G-1200 & G-1700 EVAPORATOR REPLACEMENT

Mounting Instructions

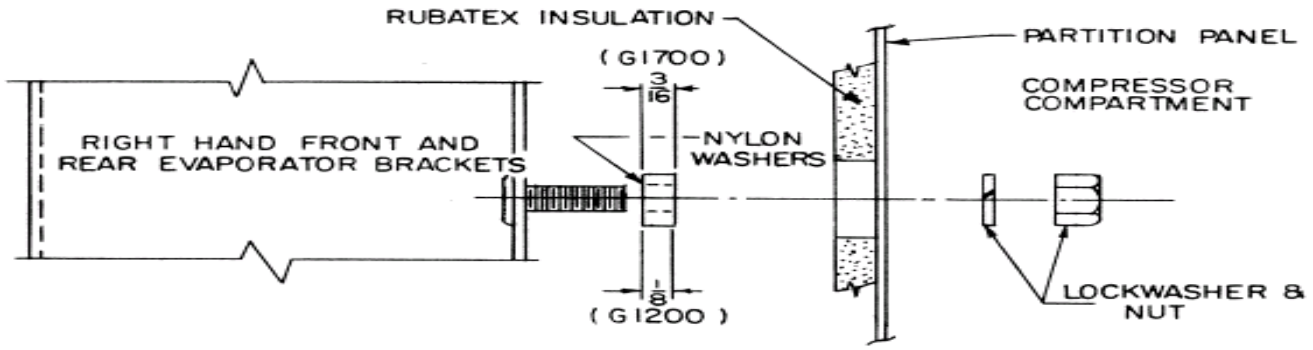
Two nylon washers are being shipped along with the evaporator (see detail below). When mounting the evaporator, you will find that, on the partition panel and Rubatex insulation, there are six holes. Due to an engineering change, the six holes for mounting the right-hand front and rear evaporator brackets have been reduced to four (two holes in center will not be used). Slip the four washers over the studs of the brackets. When the right-hand evaporator brackets with the washers are being tightened, the nylon washers must rest flat onto the partition panel surface. Avoid Rubatex insulation being pinched underneath the washers.

The plastic bag contains three nylon washers. Two of these three washers are actually used for mounting each replacement evaporator. The nylon washer left over is being shipped in case one washer becomes lost.
